NOTE: TENSION CONTROL BOLTS TO BE USED FOR ALL CONNECTIONS		CONSULTED AS CONTRACT CHANGES ADOPTED BY THE NATIONAL INSTITUTE OF STEEL DETAILING 1977.	
		△10. 4/10/06 PER CHECK	△9. 2/28/06 PER APPROVAL △9. 1/10/06 PER REC INFO
PAINT	ONE SHOP COAT U/NOTED	△4. 7/9 PER APPROVAL	△8. 3/5 FOR FIELD (SEQ#5-26)
MATERIAL	A572 GD50	△4. 1/11 PER CHECK	△4. 1/24 PER APPROVAL
HOLES	15/16" U/NOTED	△4. 1/07 ADD MARKING	△4. 11/18 PER APPROVALS (110)
ELECTRODES	E70XX	△4. 12/31 PER CHECK	△4. 10/14 PER CHECK
TOTAL WEIGHT		NO DATE	NO DATE DESCRIPTION
DIAG. REF #		REVISIONS	
WEIR WELDING CO. INC.			
DRAFTER TN	NC-30G		CONTRACT NO
DATE 08/14/01			S-615
CHECKED JBIII	MAIN BUILDING SOUTH		DWG NO E1

SILVERITE CONSTRUCTION CO., INC.
NEWTOWN CREEK W.P.C.P. WP-283
FINAL UPGRADE PROJECT NC-30G

DATE: 2/12/03
CONTRACT NUMBER: NC-30G
ITEM: FRAMING PLAN SOUTH BUILDING
SPECIFICATION SECTION: 0510
PAGE NO.: 211
PARA NO.: 211
DRAWING NO.: 30G-315-01-1001 30G-315-58
LOCATION: MAIN BLDG. SOUTH
MANUFACTURER: WEIR WELDING CO.
SUBMITTAL NO.: 10120-037
APPROVED BY: SV

DRAFTER AF	NC-30G	CONTRACT NO
DATE 08/14/01		S-615
CHECKED GS	MAIN BUILDING SOUTH	DWG NO
DATE 9/16/02		E3-S

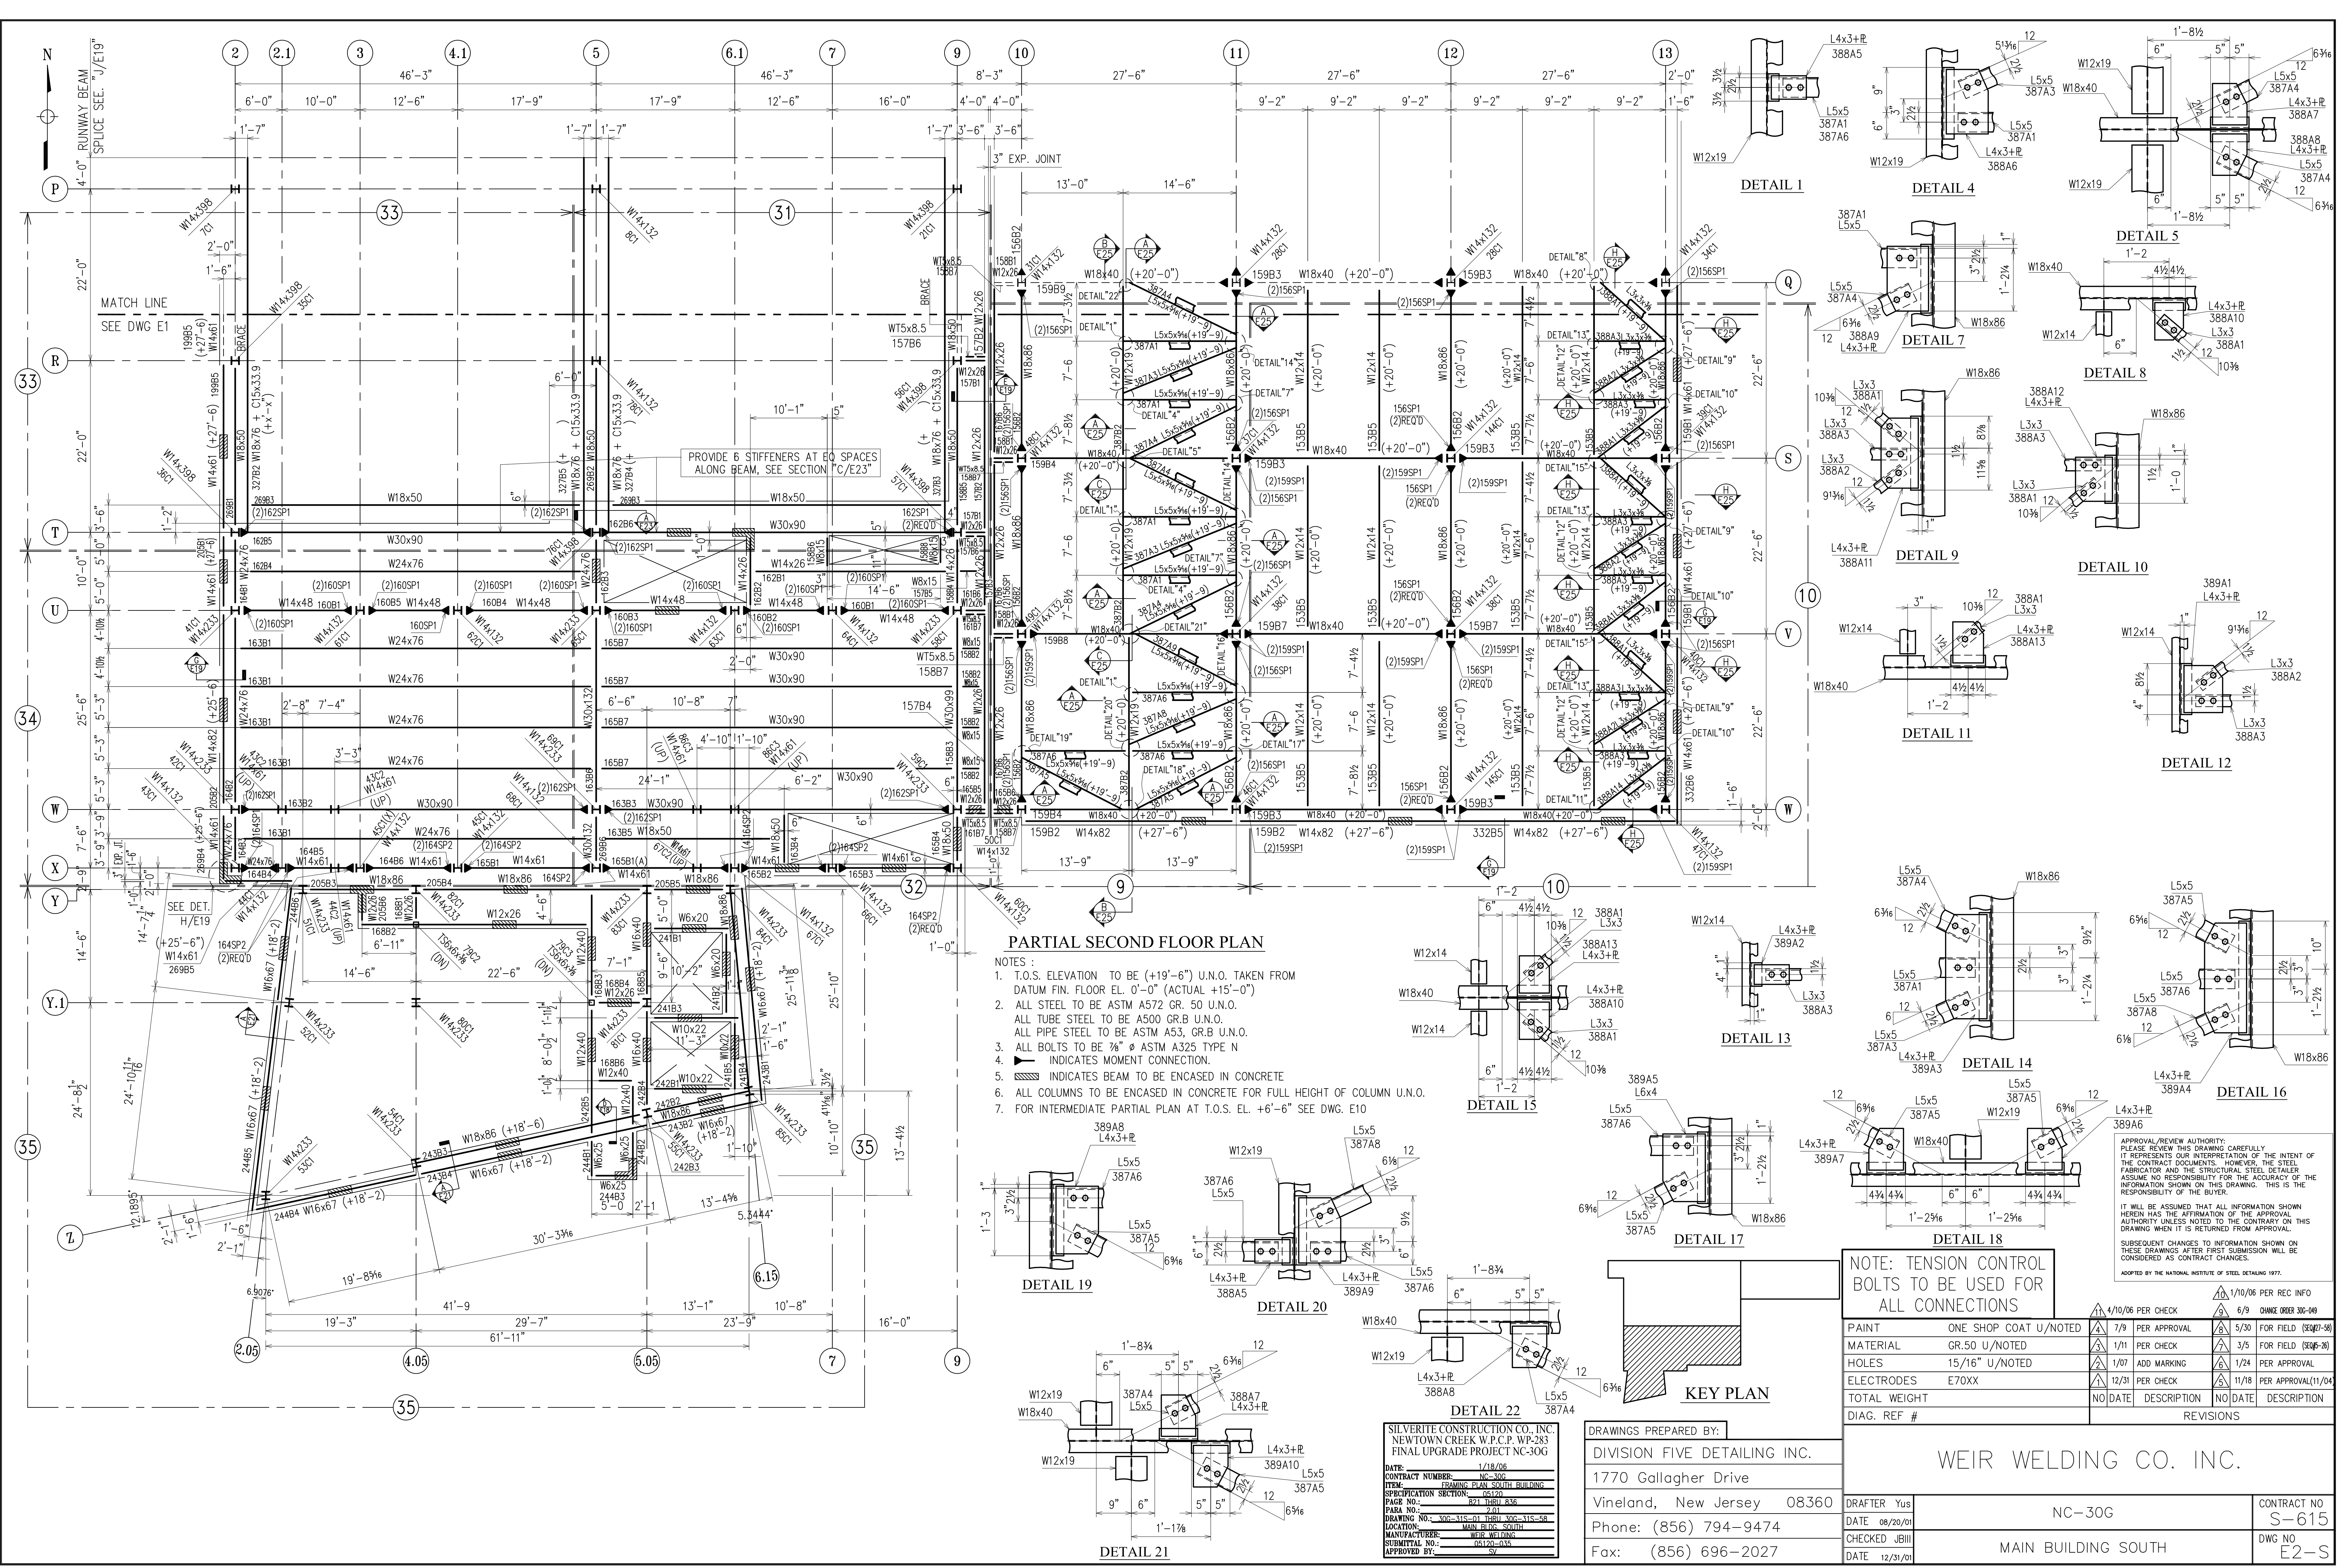
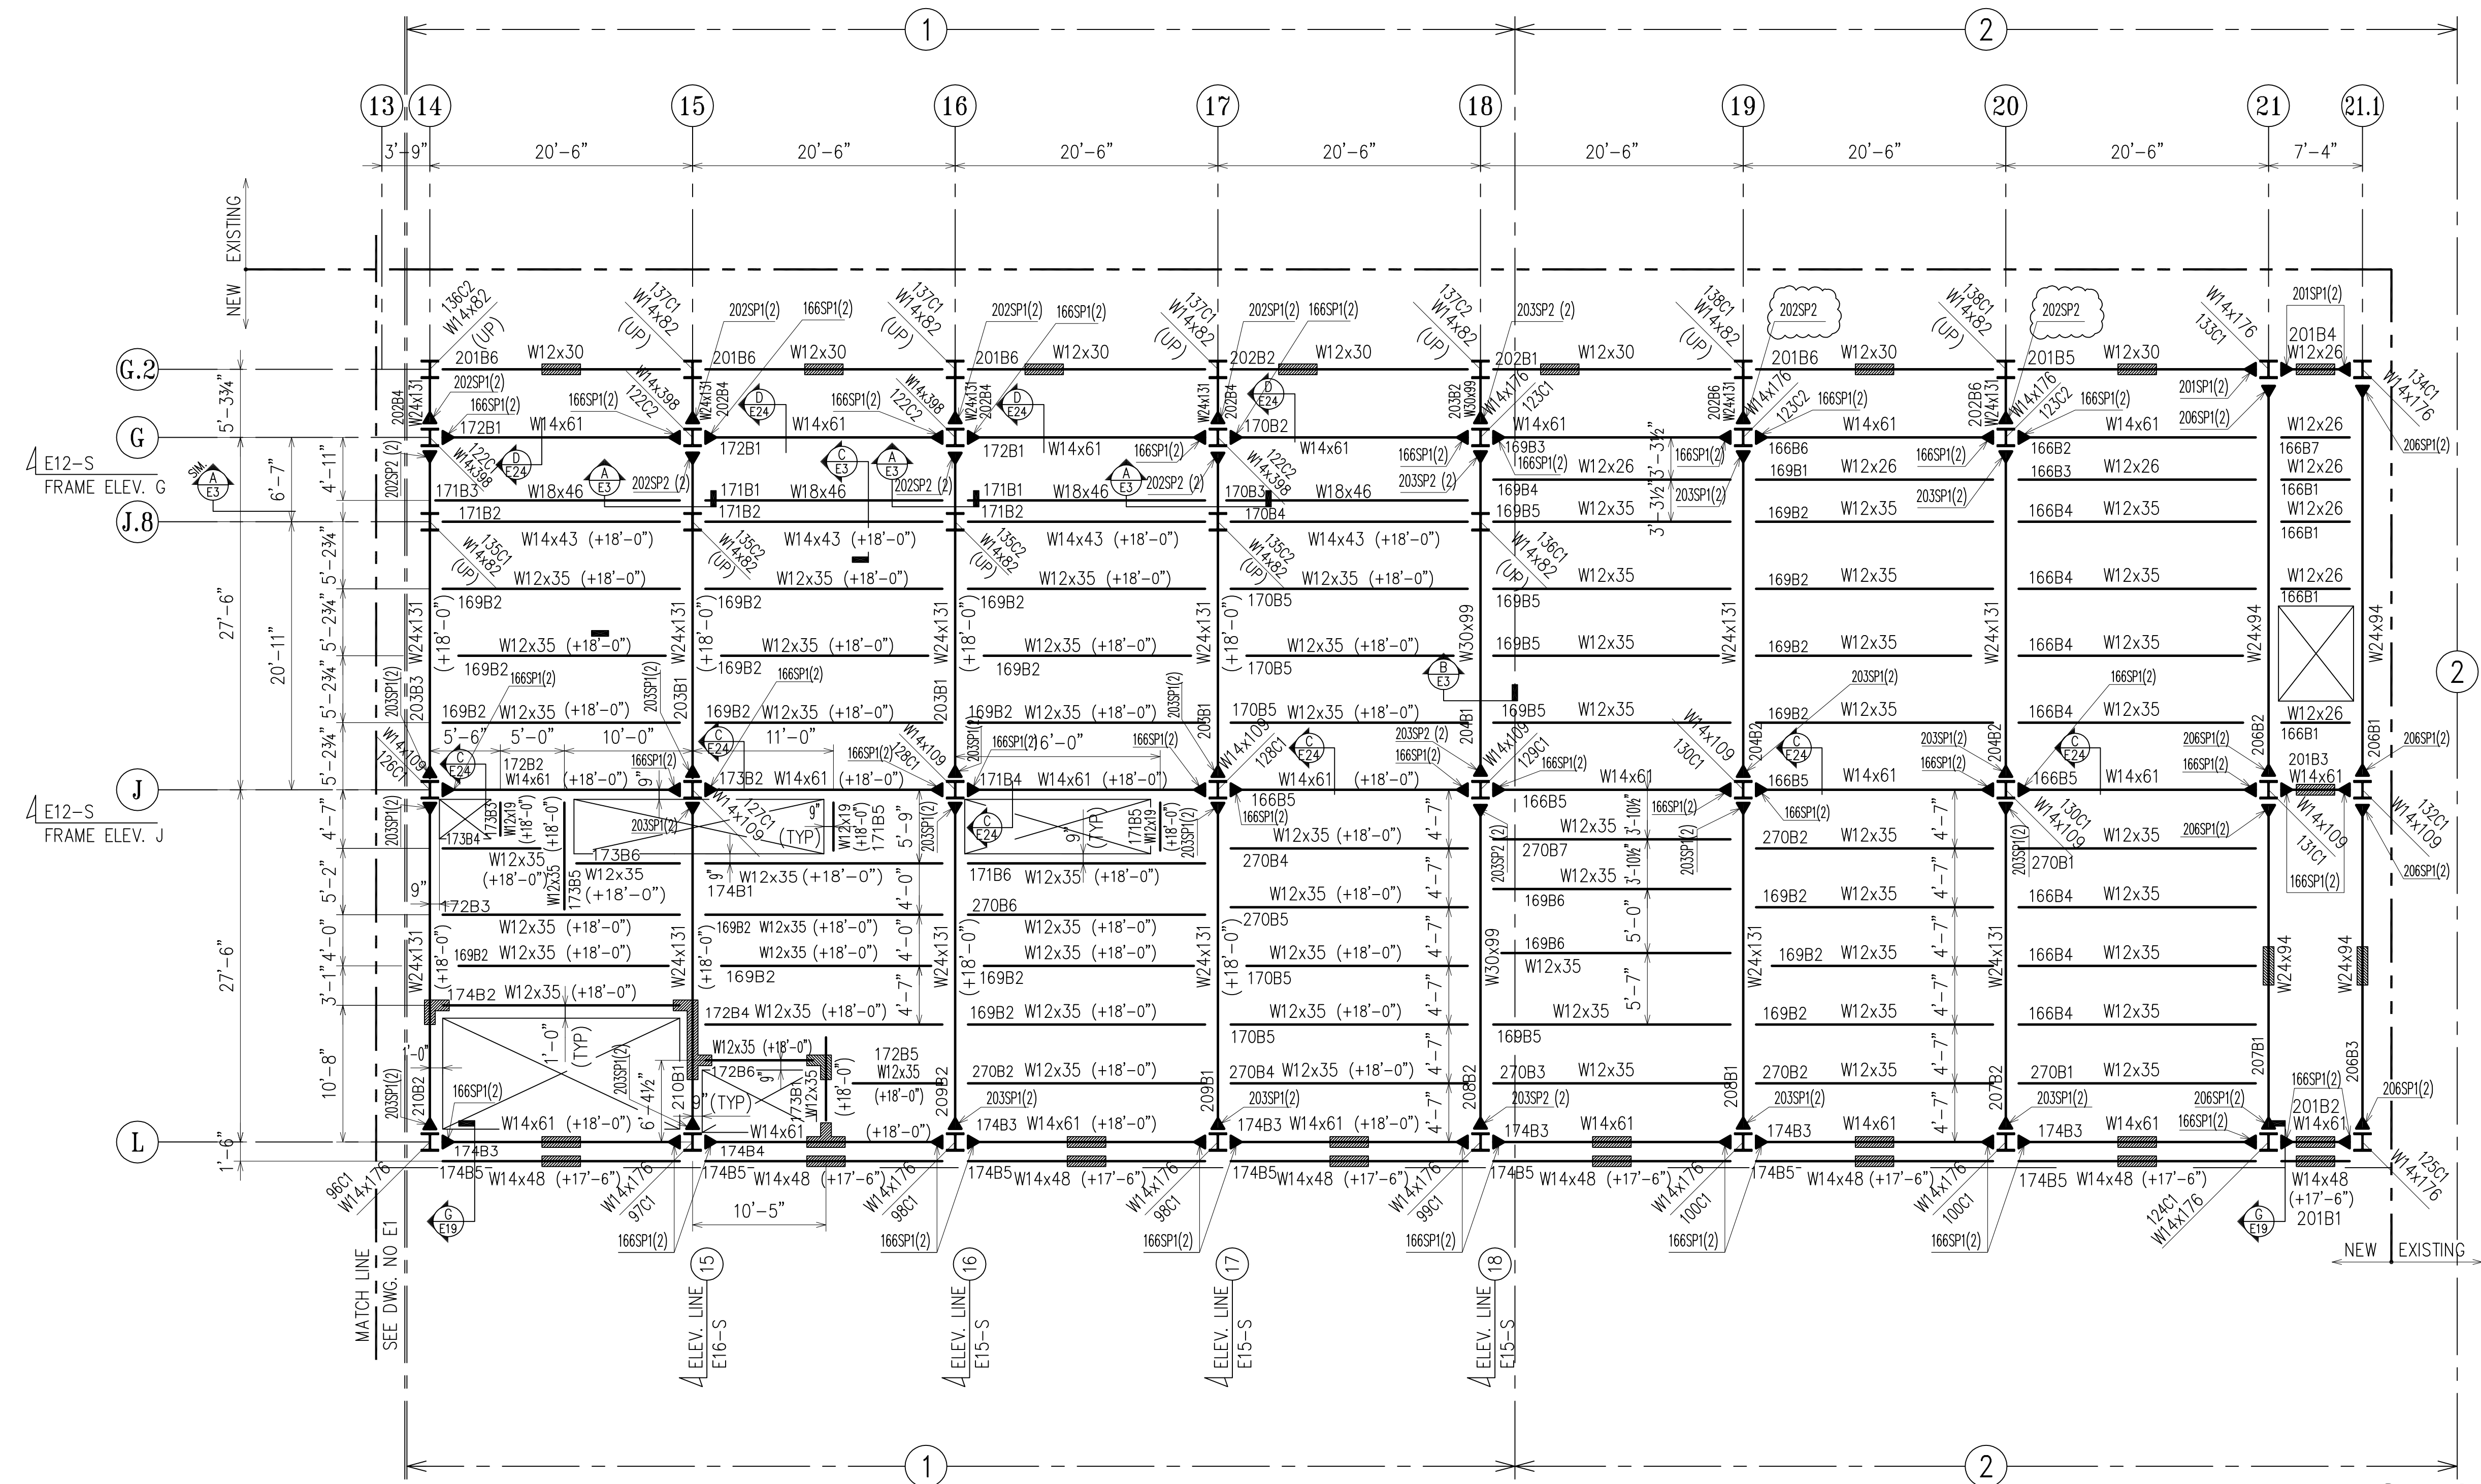
MARKINGS HAS BEEN ADDED
FOR SHIMS AT EACH MOMENT
CONNECTION

DRAFTER	YG	NC-30G	CONTRACT NO.	S-615
DATE	08/24/01		DWG NO.	E17-S
CHECKED	JIBI	MAIN BUILDING SOUTH		
DATE	1/30/02

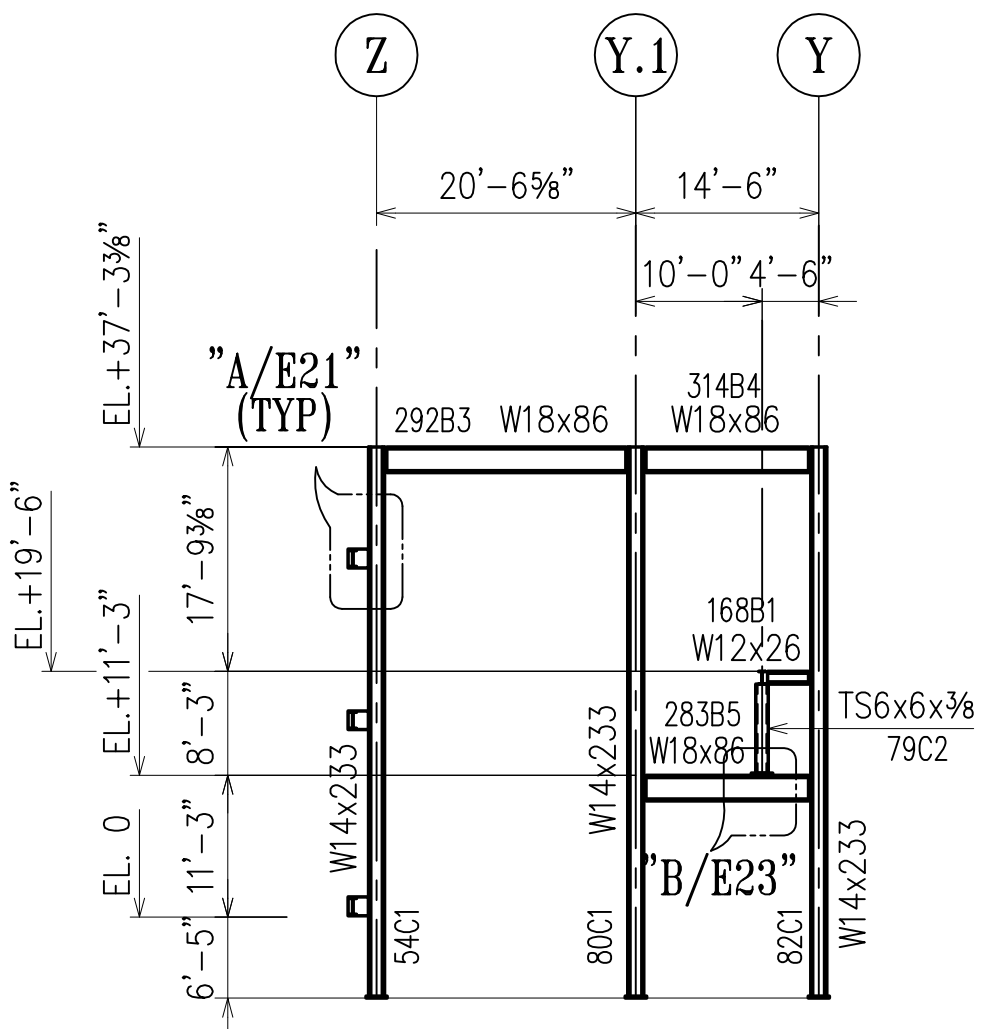
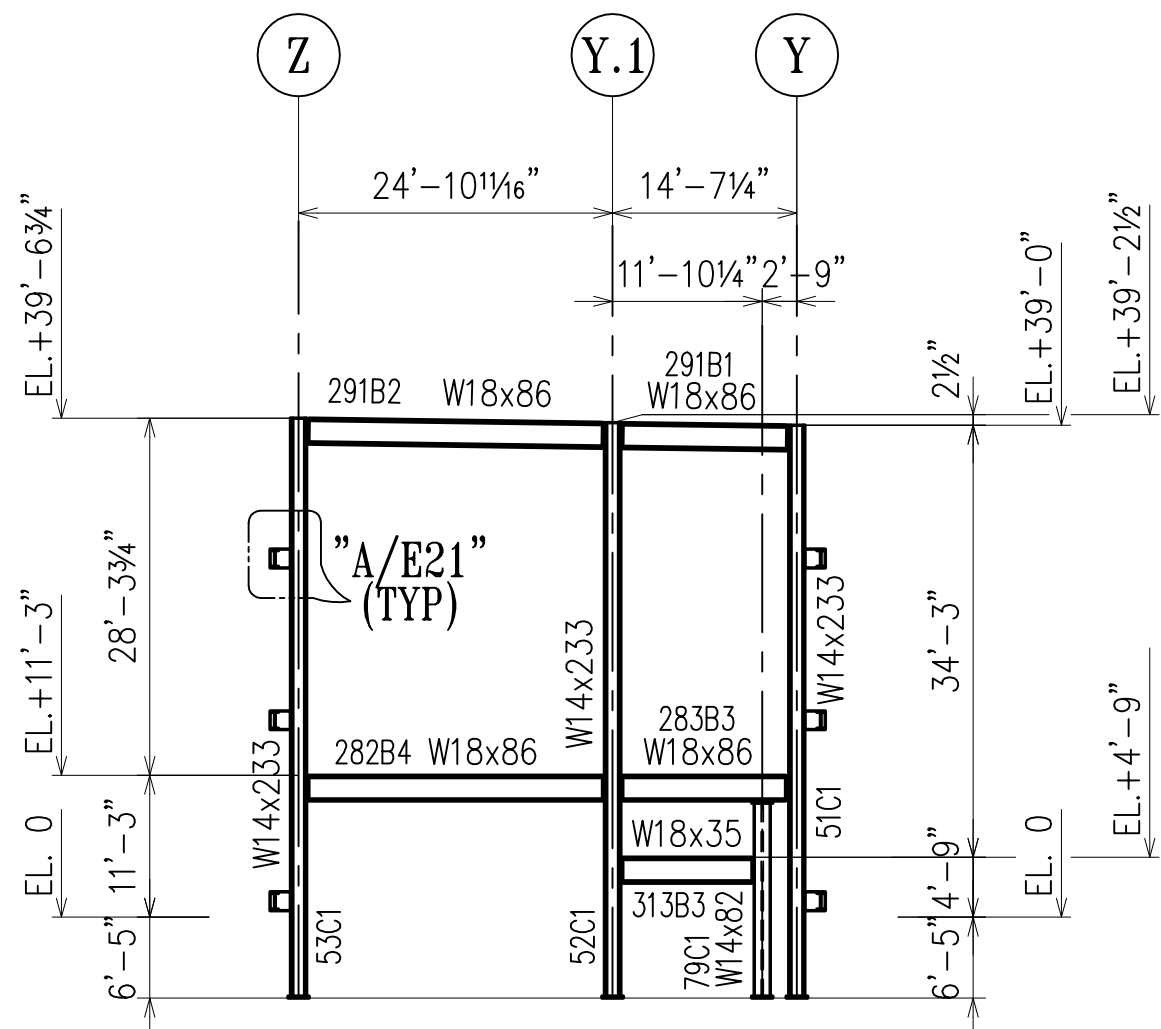
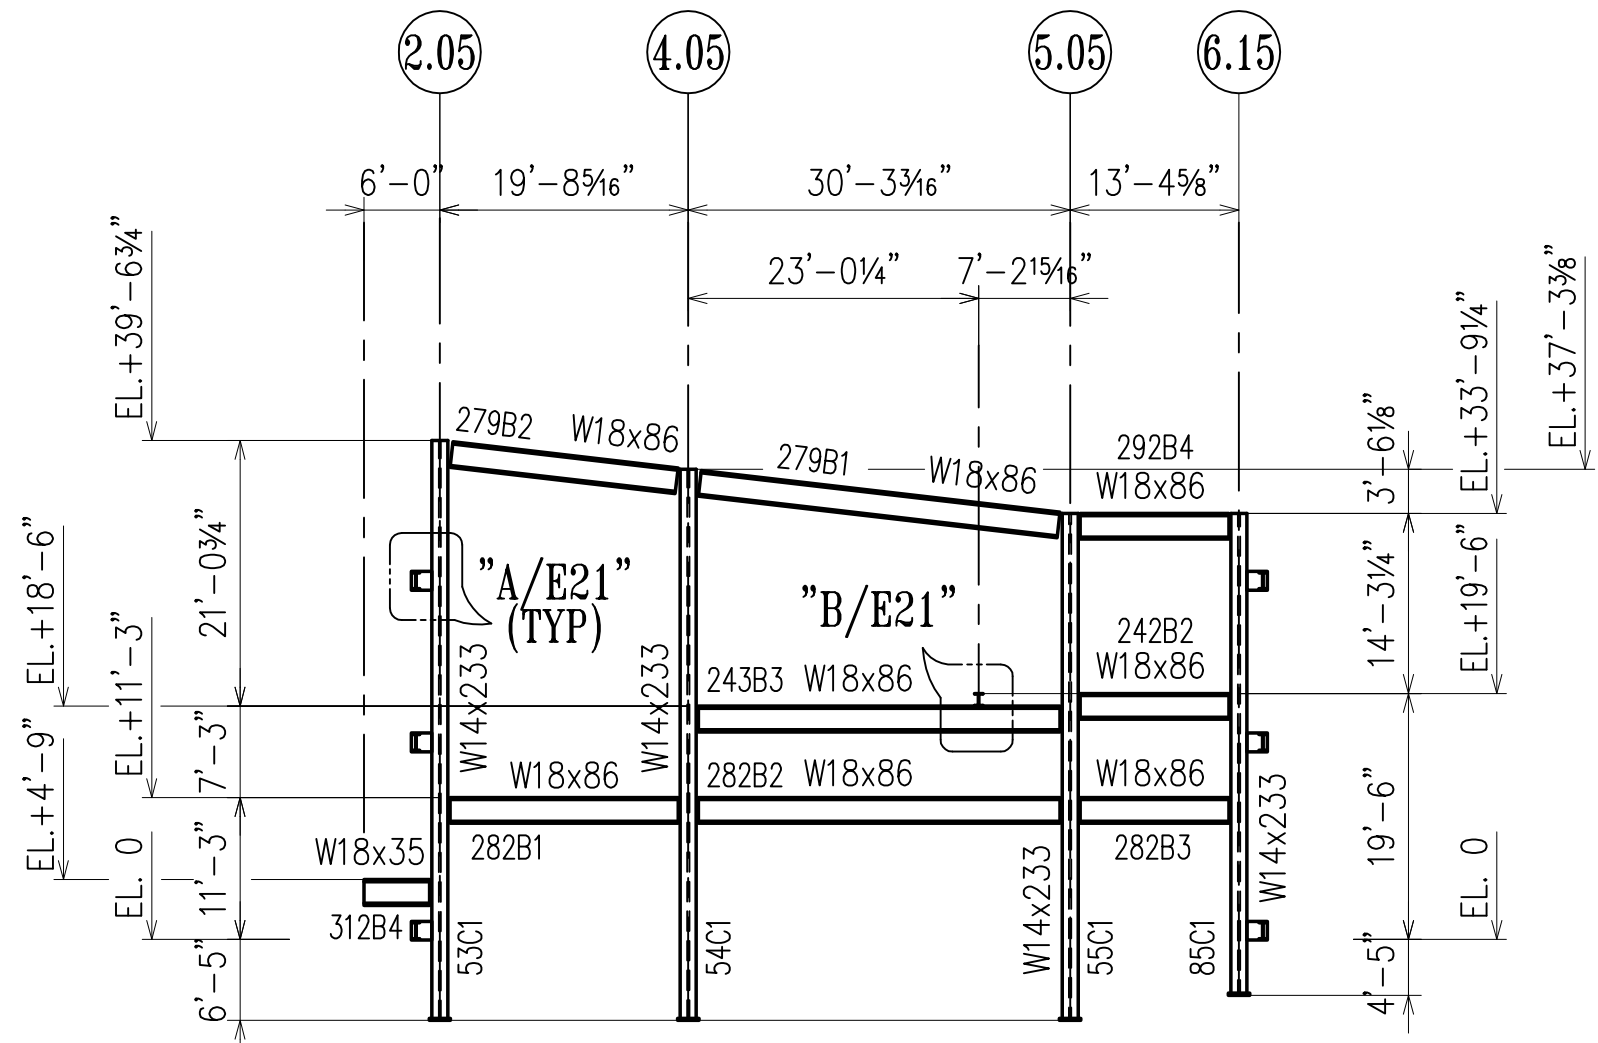
PLEASE VERIFY/SUPPLY
CLOUDED DIMS
